**MENDOCINO HISTORICAL REVIEW BOARD
STAFF REPORT**

**MHRB_2018-0005
MARCH 5, 2018**

PROJECT DESCRIPTION: A Mendocino Historical Review Board Permit request to amend MHRB_2015-0022 by changing the color/finish on the Pump House and Tool Shed and adding roof vents and entry lighting on same. Note: This location is listed in the Mendocino Town Plan Appendix 1 as a Category IIa Historic Structure "Noia House."

Picture 1)

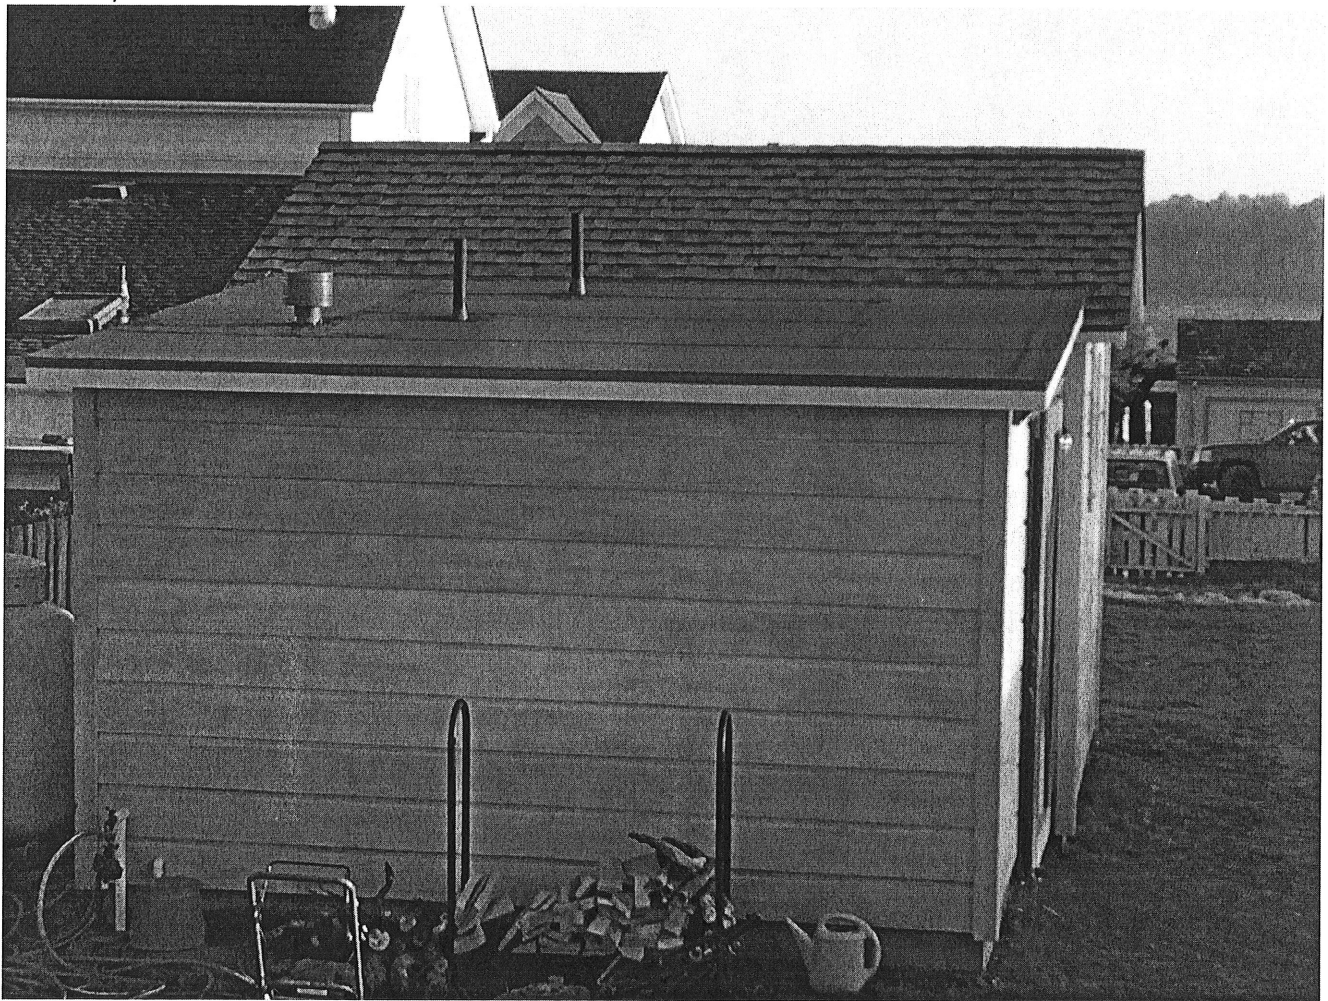
In reviewing Building Permit Application BU_2017-0530, Staff approved Pump House copper screen foundation vents and roof vents, and required the foundation vents to be screened by landscaping. While Pump House roof vents are not shown on MHRB Permit 2015-0022 elevation drawings, the Pump House floor plans show an interior laundry and sink, which would require roof vents. Staff determined that MHRB Permit 2015-0022 floor plans indicate that the Pump House would have roof vents and approved the Building Permit Application BU_2017-0530.

Staff requests the Review Board affirm Staff’s determination that the Pump House roof vents and foundation vents, screened by landscaping, are a part of MHRB Permit 2015-0022. (See Application page 9 “Picture 1” for an image showing BU_2017-0530 roof vents).

As the pumphouse was reconstructed, plumbing was installed, and our contractor, Ishvi Aum, installed two roof vents for the waste stacks and a copper roof vent for the fan. These are code requirements, and therefore mandatory. Please see picture 1), for a picture of what's been built. Note that the vents are hard to see, as they are obscured against the roofline of the pumphouse from most angles. Also, they are very similar to our neighbor's roof vents that are visible to us when I look out the back windows of our home.

- 1) The two 2" waste vents and the ventilation fan vent on the pumphouse, as they have been built. (See picture 1.)
- 2) Two 2" waste vents, and a ventilation fan vent on the toolshed. (See diagram 2.) Please note that we understand that in the actual construction, the large vent pipe may be replaced with a low profile copper vent.

Diagram 2)

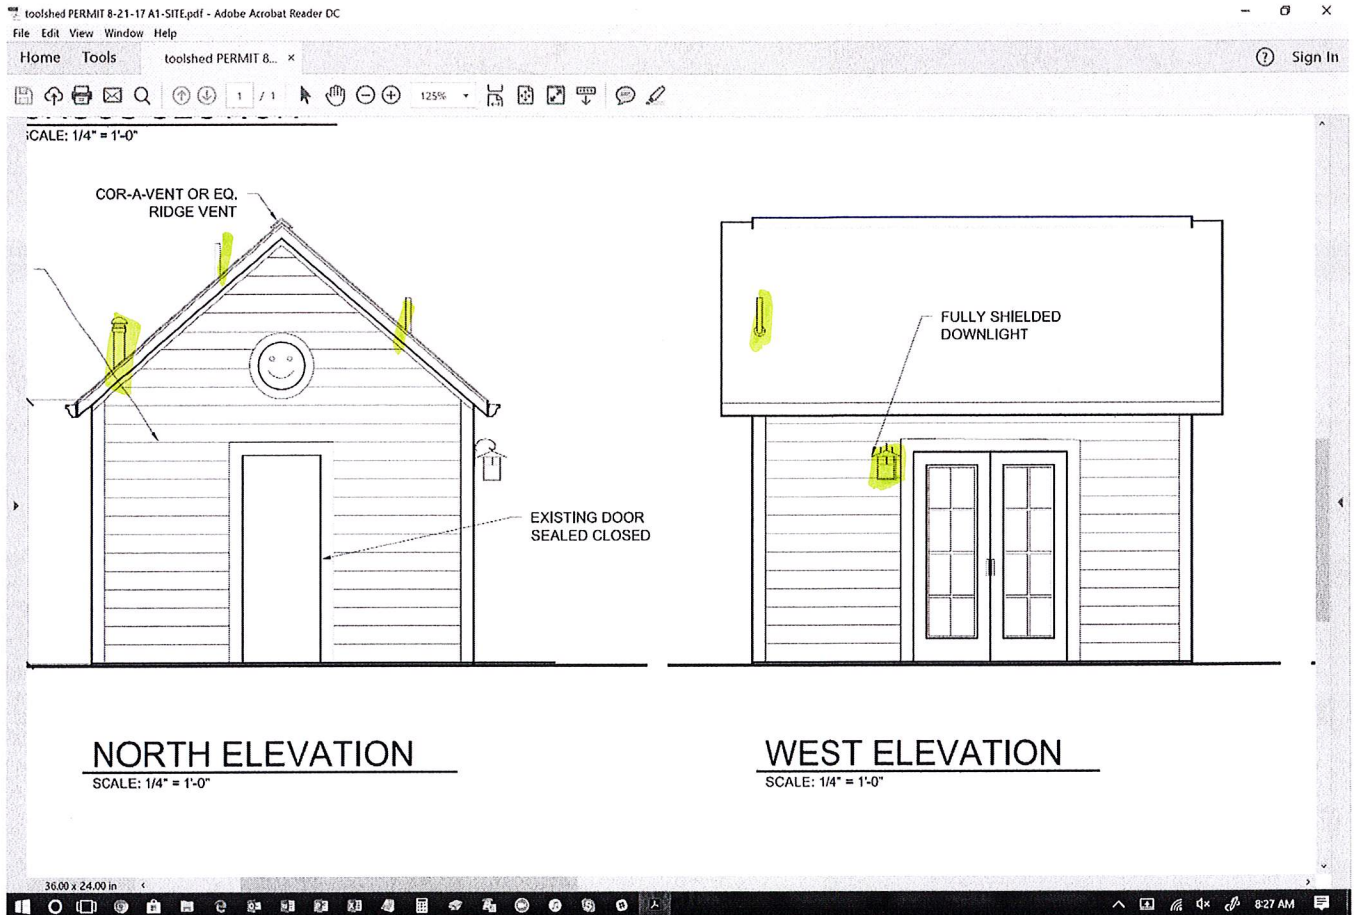
MHRB Application 2018-0005 requests to add two waste vents and ventilation fan vent on the roof of the Tool Shed, because the property owner wishes to include a sink and commode in the Tool Shed (See Application page 10 "Diagram 2" for the proposed Tool Shed vents). In addition, Staff requests the Review Board affirm that the Tool Shed double, south-facing casement window is a part of MHRB Permit 2015-0022 (See Application Description "Diagram 2").

We request that the HRB approves a downlit exterior light on the toolshed. (See diagram 2.)
